UNITED STATES
DEPARTMENT OF THE INTERIOR
BUREAU OF LAND MANAGEMENTFORM APPROVED
OMB NO. 1004-0135
Expires July 31, 2010**SUNDRY NOTICES AND REPORTS ON WELLS**
Do not use this form for proposals to drill or to re-enter an abandoned well. Use form 3160-3 (APD) for such proposals.

| 3a Address 600 NORTH MARIENFELD STREET, SUITE 600 MIDLAND, TX 79701 | 3b Phone No. (include area code) Ph: 432-620-1936 | 8 Well Name and No. LAGUNA DEEP UNIT 21 |

Cimarex Energy respectfully requests approval to include a 2M diverter system.

20" Diverter System

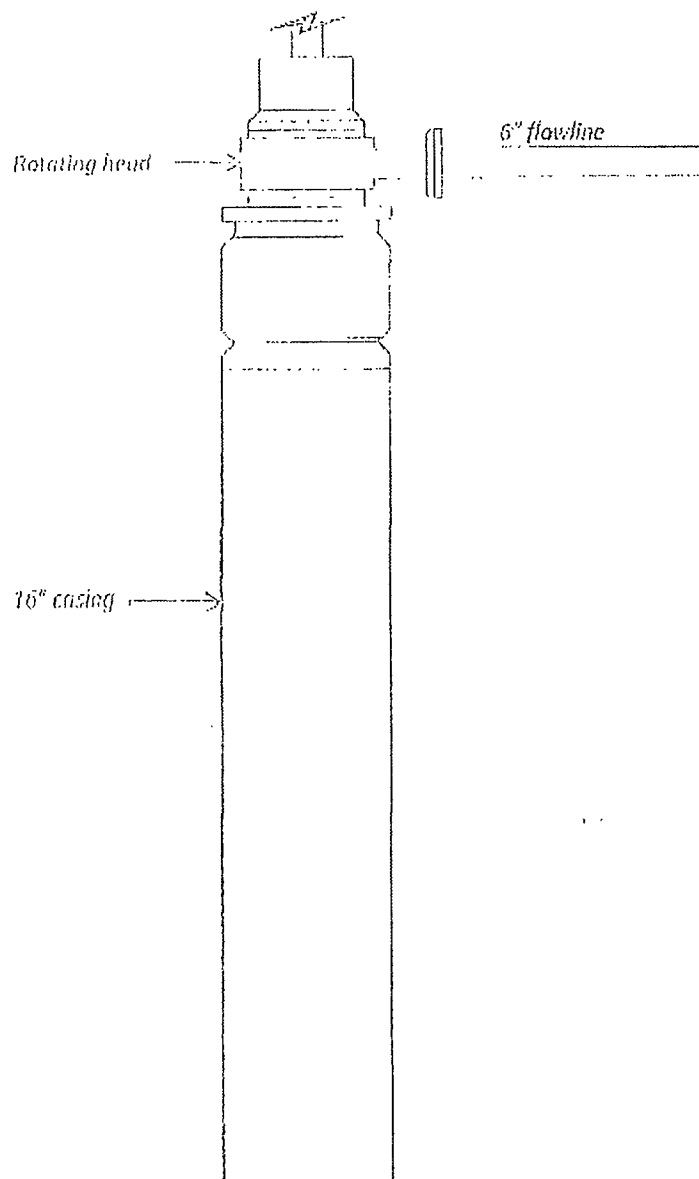
Previously approved permit indicates BOP to be nipped up from the base of the 16" casing to TD. Cimarex requests the use of a diverter system to be nipped up on the 16" casing. The diverter system will consist of an annular preventer and a rotating head. It will be tested to 250 psi low and 500 psi high (see attached.)

Cimarex will nipple up BOP as proposed in the approved permit from the base of the 11-3/4" intermediate csg to TD.
